ADDENDUM FOUR
Water Treatment Plant
High Service Pump Upgrades
TDEC Project No.: DW20220948
City of Springfield, Tennessee
Bid No. 1250
Griggs & Maloney Project No. 1141-16

To: All Plan Holders
Owner: City of Springfield, Tennessee
Engineer: Griggs & Maloney, Inc.
Project: Water Treatment Plant
High Service Pump Upgrades
File 1141-16
TDEC Project No.: DW20220948

ELECTRICAL DEMO - PLAN VIEW
SCALE: 3/16" = 1'-0"

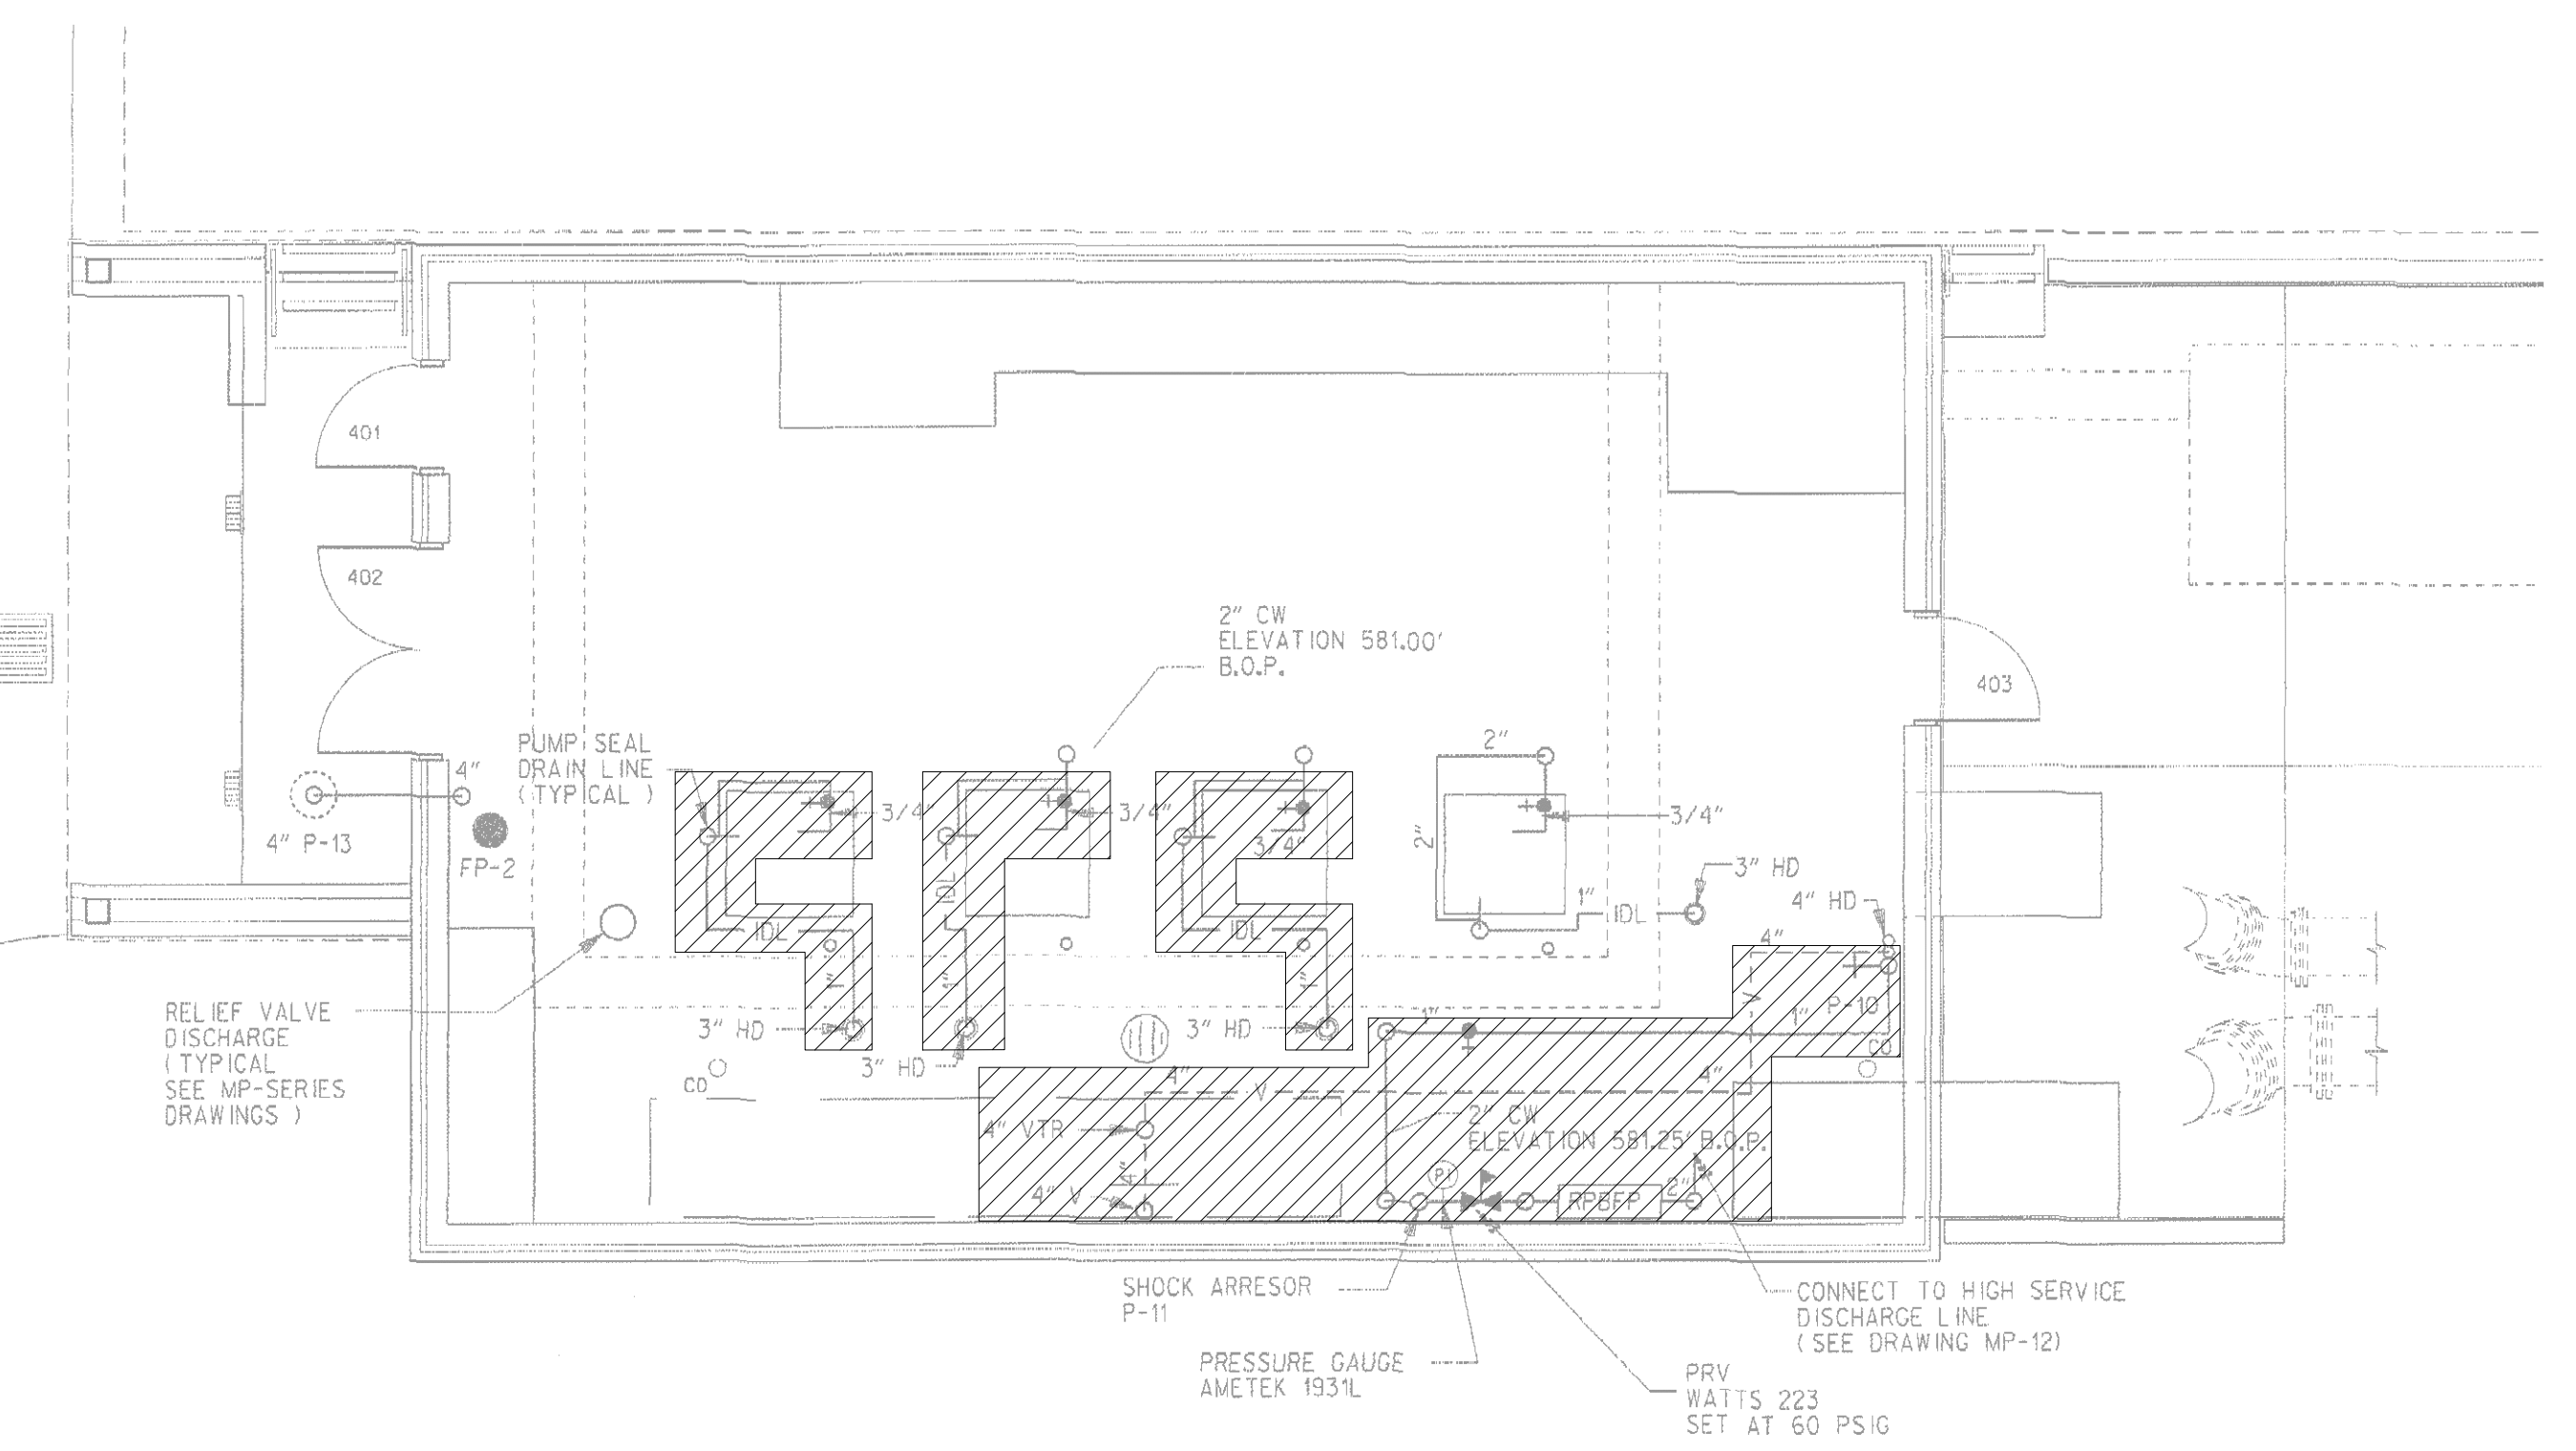
6. **SHEET D1.1 DEMOLITION PLAN – HIGH SERVICE PUMP BUILDING** – See NEW Sheet D1.1 attached.
7. **SHEET M1 NEW CLEARWELL PLAN VIEW** – Redefine ports as one level measuring port and one float port. See re-issued Sheet M1 attached.

SECTION
SCALE: 1/4" = 1'-0"
DETAIL FOR CONNECTION TO EXISTING CLEARWELL
SCALE: 1/4" = 1'-0"

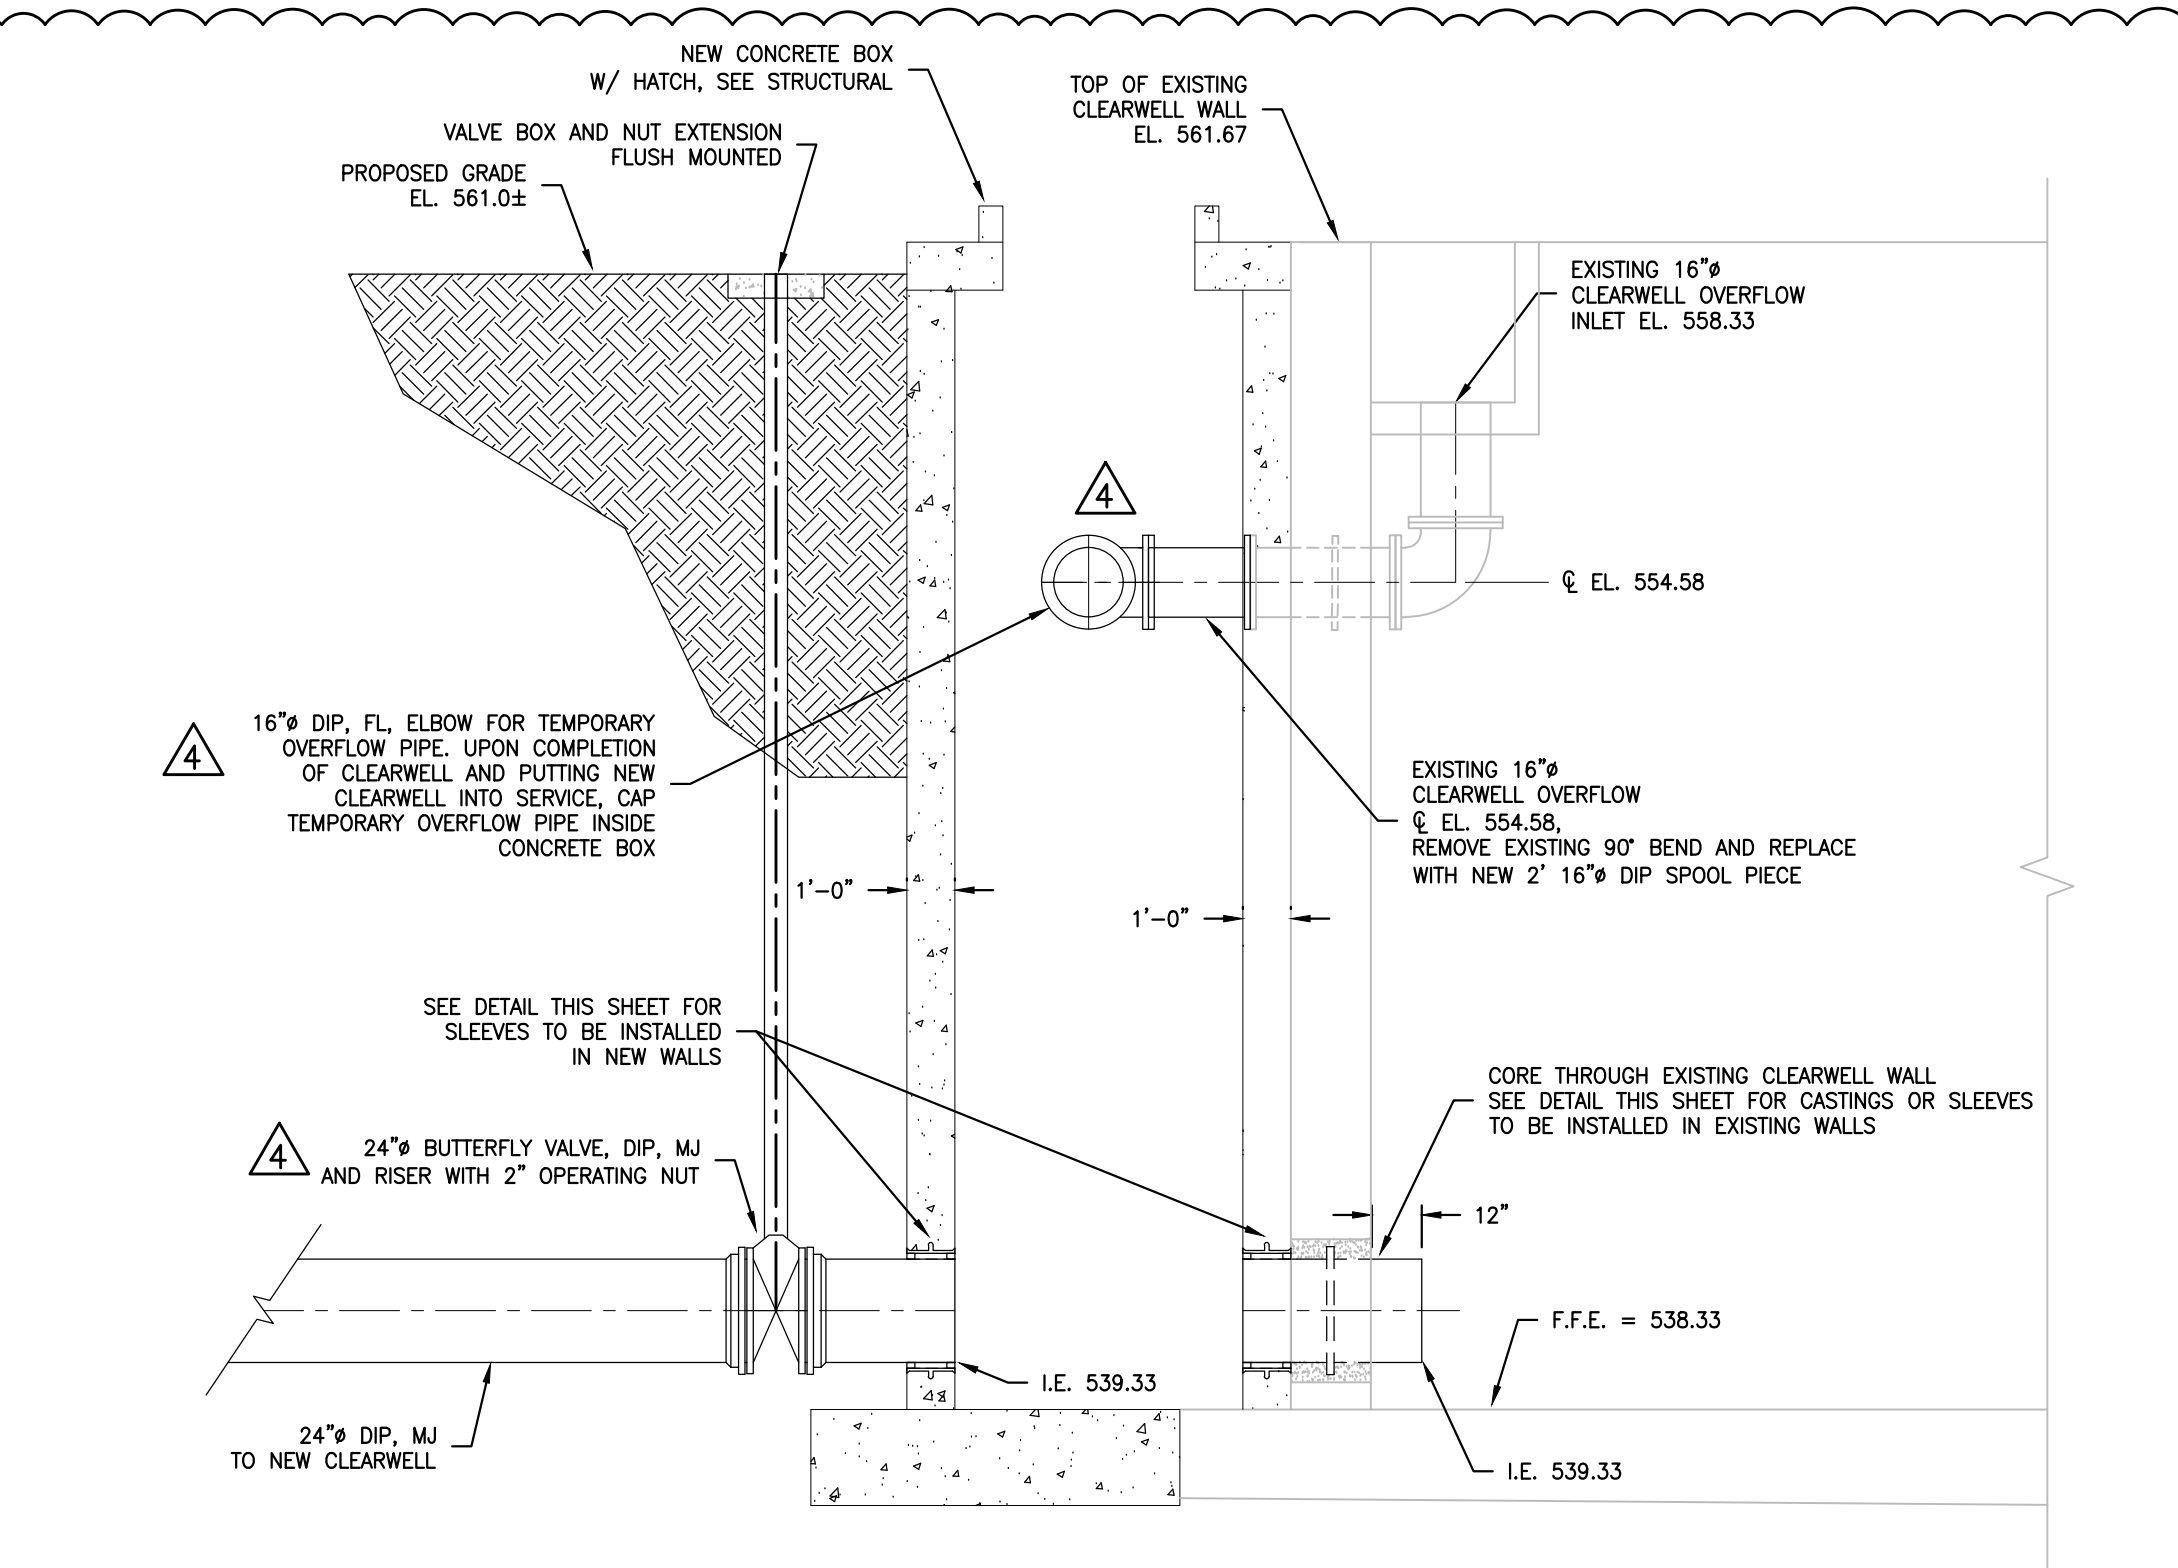
8. **SHEET M2 NEW CLEARWELL SECTION A & B AND DETAIL FOR CONNECTING TO EXISTING CLEARWELL** – Revised DETAIL FOR CONNECTION TO EXISTING CLEARWELL. See re-issued Sheet M2 attached.

HIGH AND LOW WATER LEVEL FLOAT SWITCHES DETAIL
SCALE: NONE

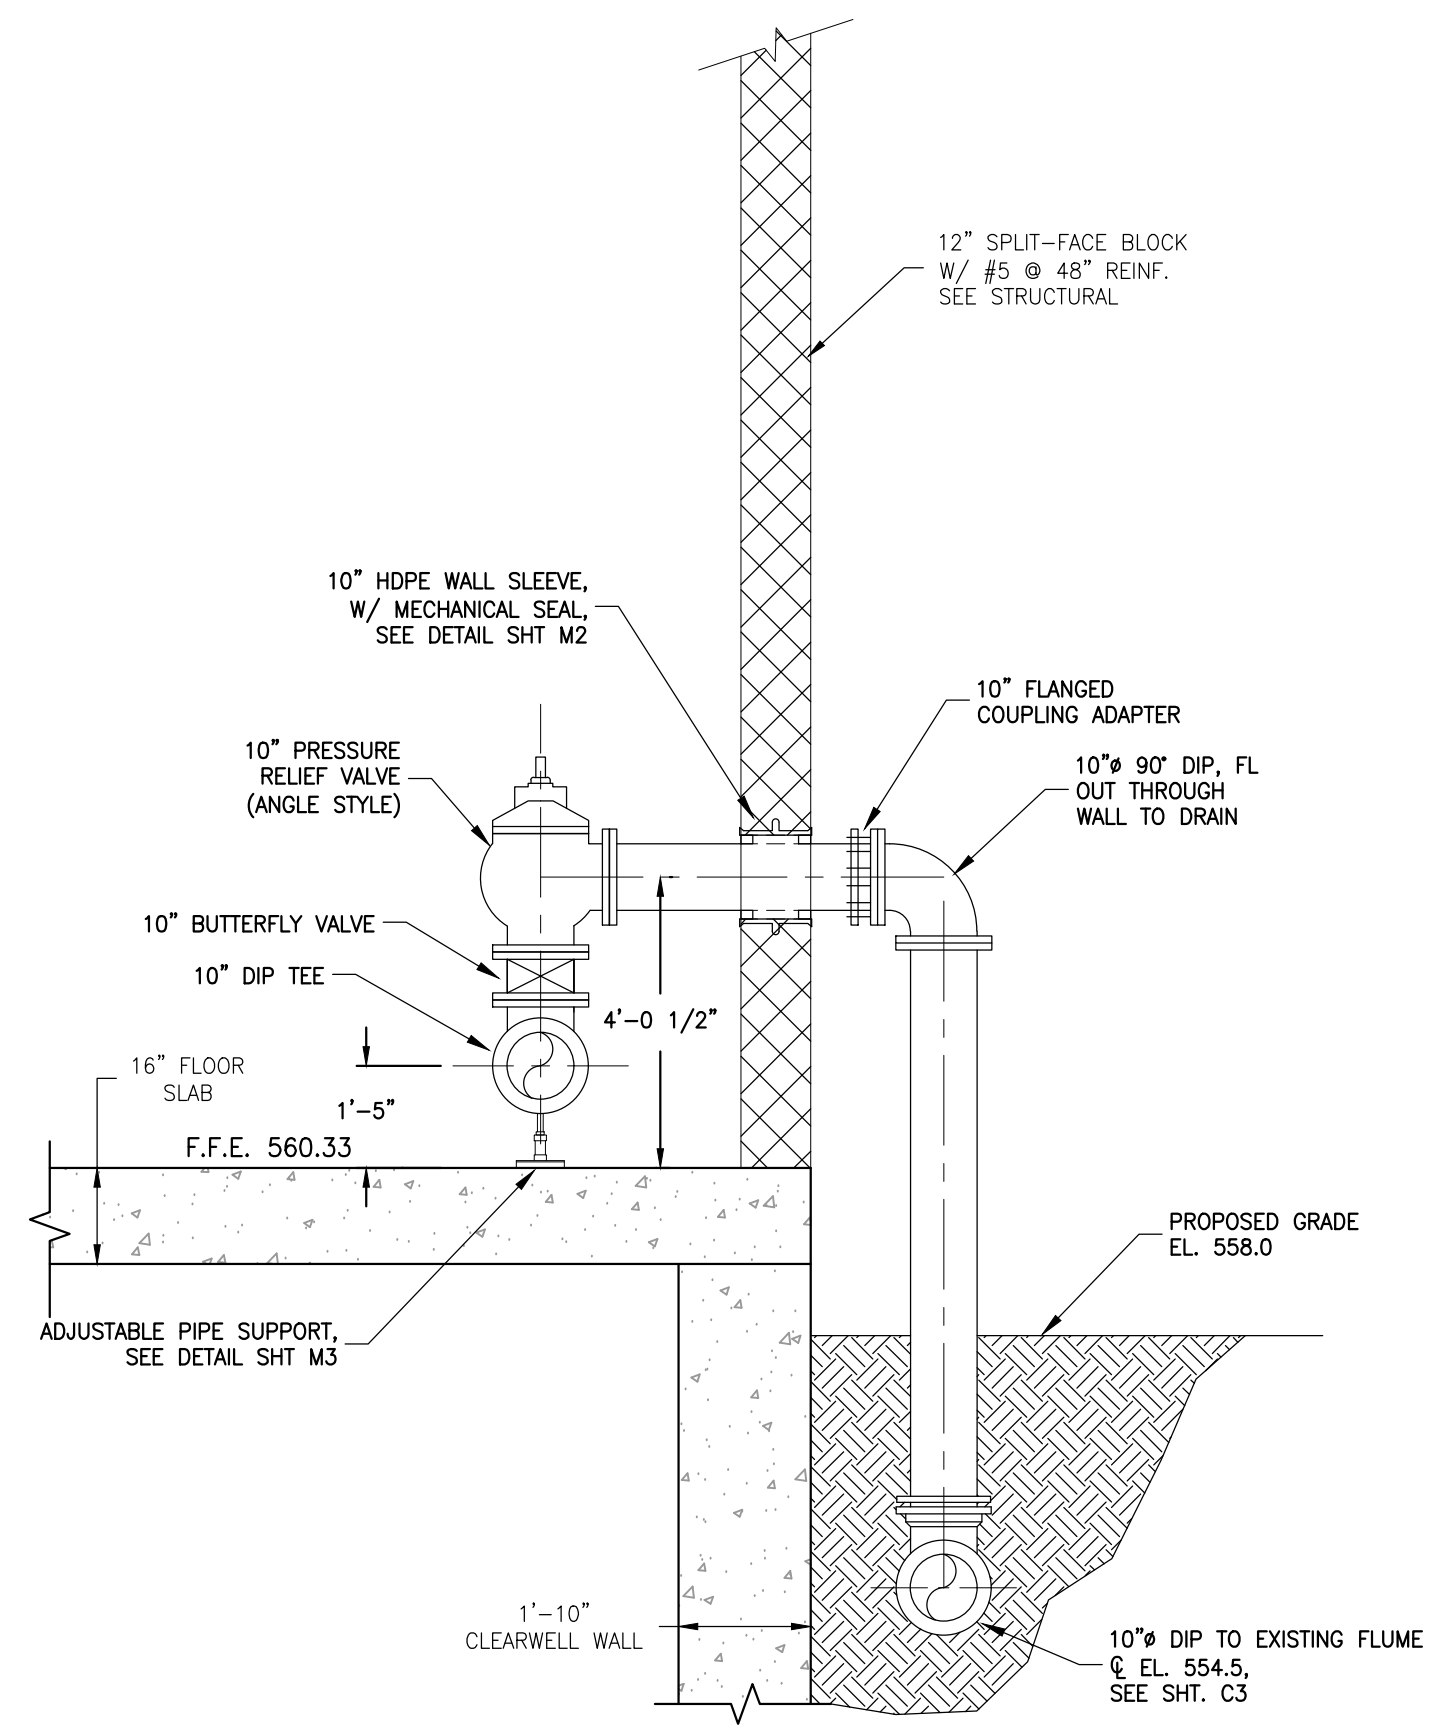
9. **SHEET M3 NEW PUMP AREA – PLAN & SECTION A-A** – Revised Air Release Valve Reference. See re-issued Sheet M3 attached.
10. **SHEET M4 NEW PUMP AREA SECTIONS B-B, C-C & D-D** – NEW HIGH AND LOW WATER LEVEL FLOAT SWITCHES DETAIL. See re-issued Sheet M4 attached.
11. **ADDENDUM 1 SHEET 1 OF 3 SITE PLAN** – Add four new butterfly valves to table of owner supplied equipment. See re-issued Sheet 1 of 3 attached.
12. **SHEET E-101** – See re-issued Sheet E-101 attached.
13. **SHEET E-102** – See re-issued Sheet E-102 attached.
14. **SHEET E-201** – See re-issued Sheet E-201 attached.
15. **SHEET E-301** – See NEW Sheet E-302 attached.
